Interactive comment on “Development and characterization of a High-Temperature Proton-Transfer-Reaction Mass Spectrometer (HT-PTR-MS)” by T. Mikoviny et al.

Received and published: 8 April 2010

Fig. 1.

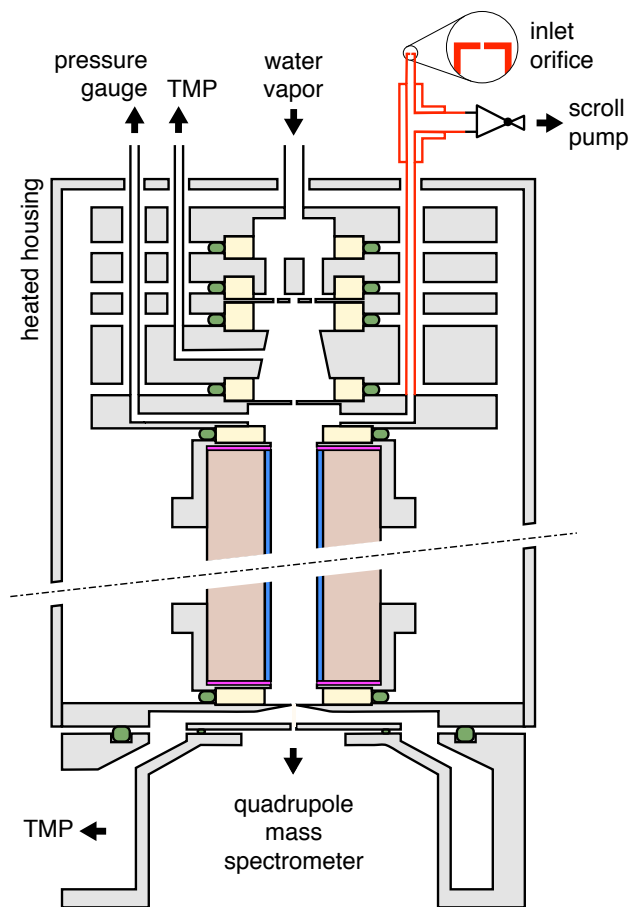
Page 189 - description of the new hollow cathode (HC) ion source design. Traditional HC ion sources have a water flow exhaust line that is pumped. This new design seems to lack this feature. Is this an oversight in the schematic or can the HC source be operated without this pumped exhaust line? It is my understanding that the HC ion source must operate at a pressure lower than the drift tube. The authors need to comment on this change or adapt their schematic to show the presence of this exhaust line.

Page 189, line 10 - The authors state there are “three 0.5 mm diameter orifices which were aligned with the hollow cathode cylinders.” I guess I don’t understand this statement. I see that the drift tube is bound on either end by apertures and that there is another aperture at the entrance to the quadrupole mass spectrometer. Are the authors referring to these apertures? If so, I ask that the authors expand their discussion to more clearly identify the location of the three apertures being referred to.

Figure 1 - It seems that there should be a valve or second aperture in front of the scroll pump on the inlet line, otherwise the drift tube pressure would be reduced to the backing pressure of the scroll pump.

The reviewer is correct. We had overlooked this detail. The schematic has been adapted.

To clarify the details, we have expanded our discussion and have also adapted our schematics (Fig. 1). “The exit anode lens had one central orifice of 0.8 mm diameter and three 0.5 mm diameter orifices which were aligned with the cathode hollow cylinders. The three off-axis orifices had the primary function of reducing the pressure in the discharge region, thus improving the discharge stability.”

The schematic has been adapted to include this important detail.
